Administrative Approval Action

Case File / Name: ASR-0047-2021
DSLCL - Town Drive Apartments

TOWN DRIVE APARTMENTS

6350 TRIANGLE TOWN BOULEVARD RALEIGH, NORTH CAROLINA, 27616 ADMINISTRATIVE SITE REVIEW CITY OF RALEIGH CASE #: ASR-0047-2021

GARAGE 5 PRIMARY STREET AVERAGE GRADE

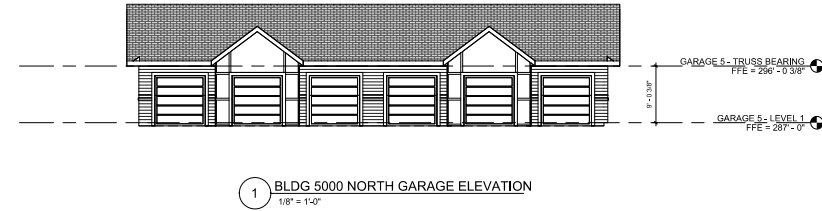
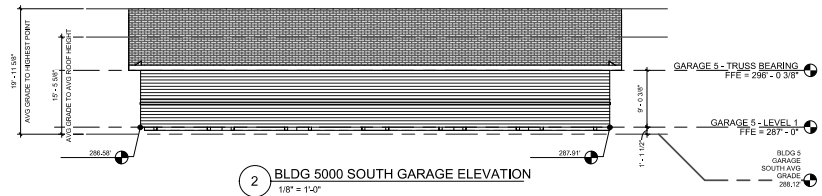
5. Revise the spot high grade, for proposed Garage #5, as listed on the South Elevation and shown on the avg. grade table, per sheet C3.08 from 286.58 to 288.33.
6. Revise the spot low grade for proposed Garage #2, as listed on the South Elevation and shown on the avg. table, per sheet C3.08, from 285.91 to 283.0.
